# UNITED STATES PATENT AND TRADEMARK OFFICE

APPLICATION NO.	FILING DATE	FIRST NAMED INVENTOR	ATTORNEY DOCKET NO.	CONFIRMATION NO.
10/085,433	02/28/2002	Yves L. Baeyens	Baeyens 1-24-4-1-1	3191
46850	7590	07/01/2005	EXAMINER	
MENDELSON & ASSOCIATES, P.C. 1500 JOHN F. KENNEDY BLVD., SUITE 405 PHILADELPHIA, PA 19102			SEDIGHIAN, REZA	
			ART UNIT	PAPER NUMBER
			2633

## Office Action Summary

FIG. 2

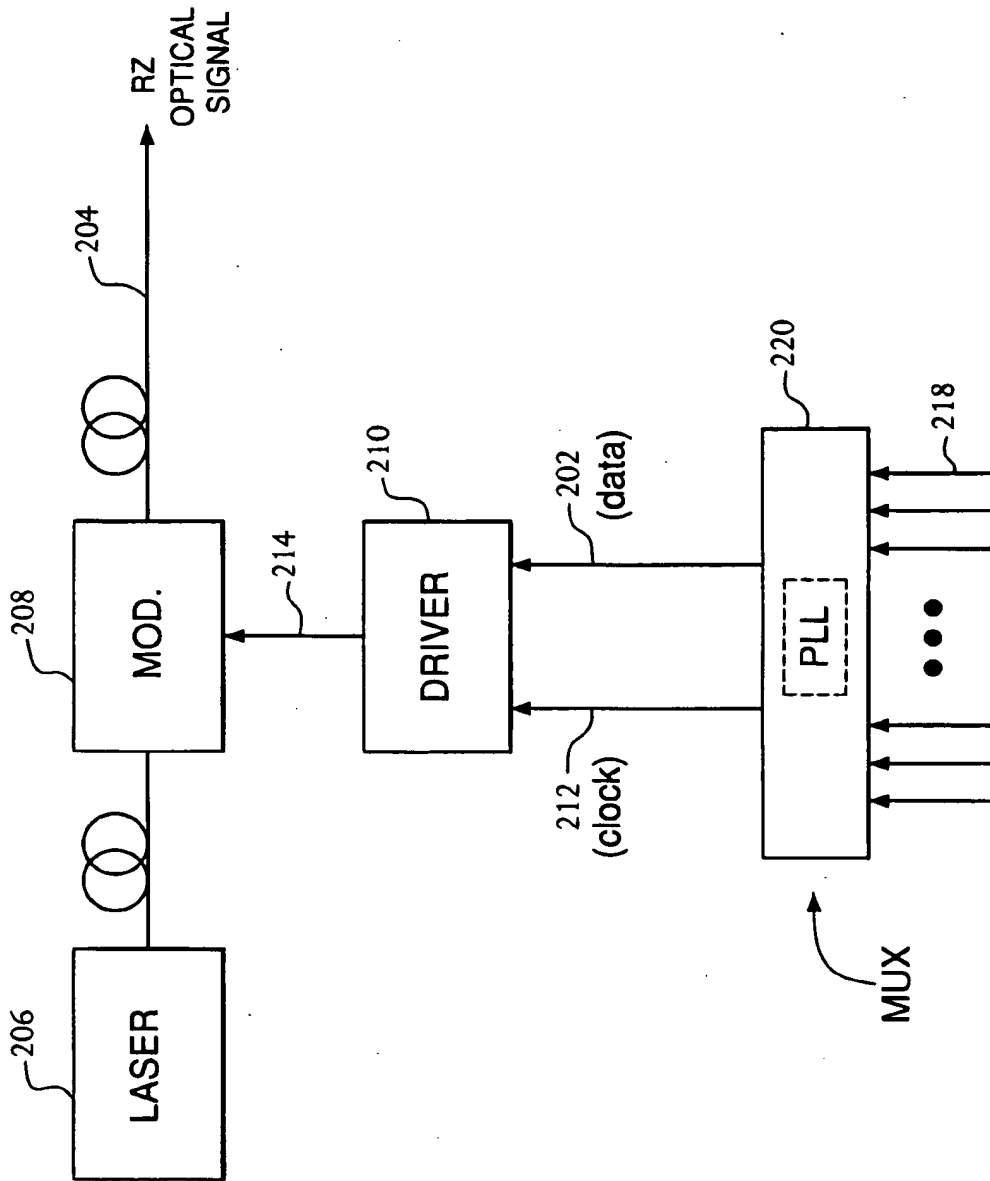
Regarding claim 13, Givehchi teaches the apparatus further comprises an electro-optic modulator (202, fig. 2) configured to receive an optical input (201, fig. 2) from a laser (230, fig. 2) and to modulate the optical input using the amplified RZ data signal to output an optical RZ data signal corresponding to the amplified RZ data signal (page 2, paragraph 0016).

Regarding claim 14, Givehchi teaches a laser that generates a continuous light emission (CW 230, fig. 2).

Regarding claims 22-23, Givehchi teaches a circuit (240, fig. 2) adapted to generate a sinusoidal signal, the sinusoidal signal being the clock signal synchronized with the NRZ data signal (page 3, paragraph 0020 and fig. 3).

FIG. 3A

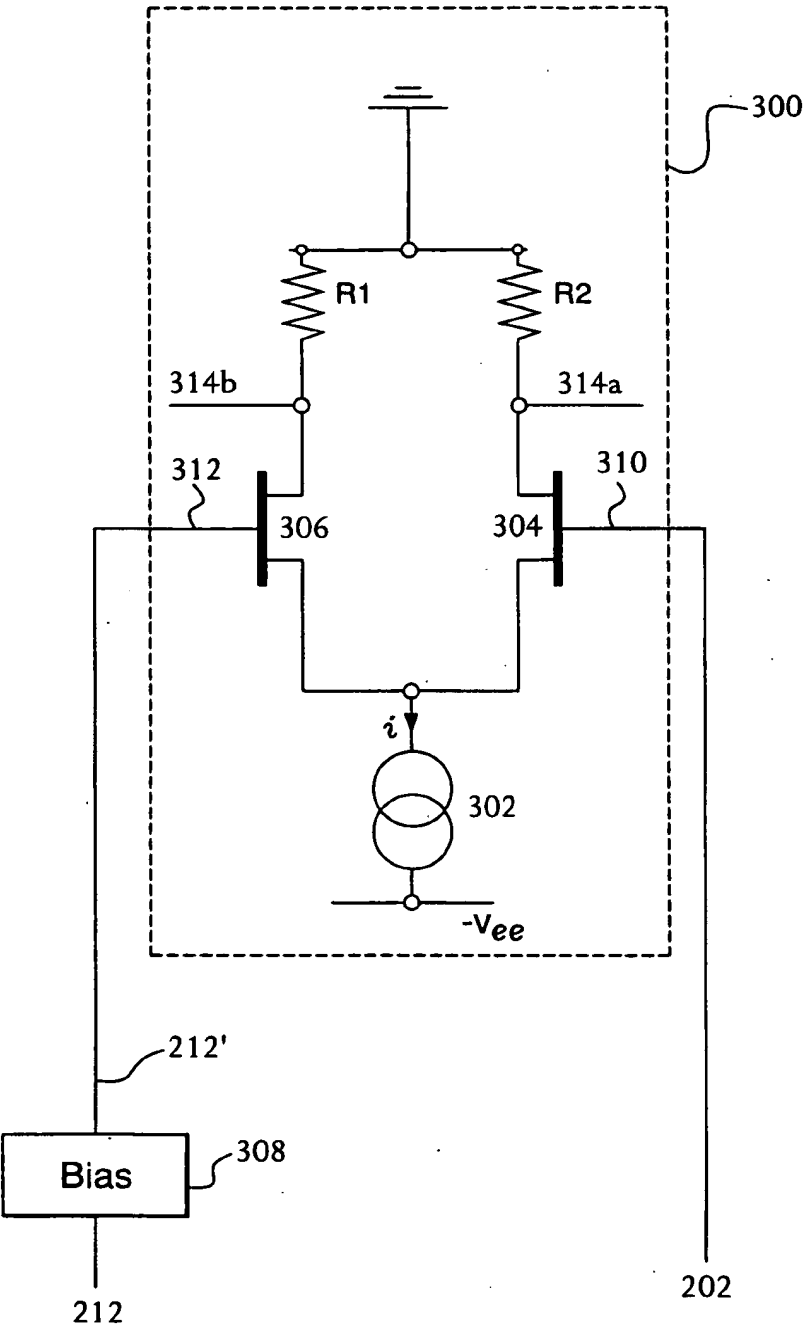
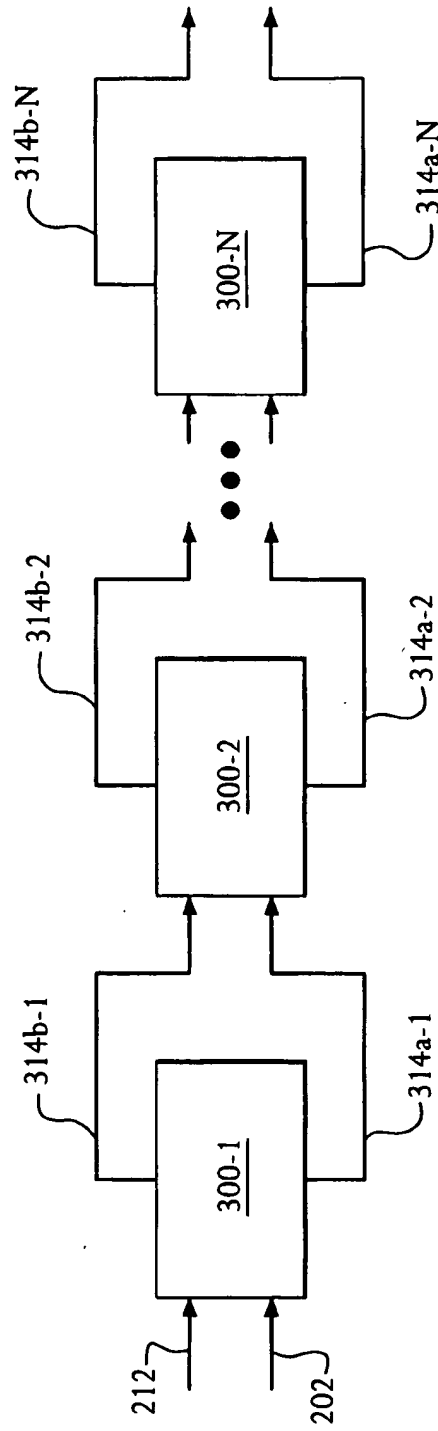
Regarding claim 5, Givehchi teaches the circuitry configured to condition at least one of the NRZ data signal and the clock signal to produce at least one of the first and second signals (page 3, paragraph 0020 and fig. 3).
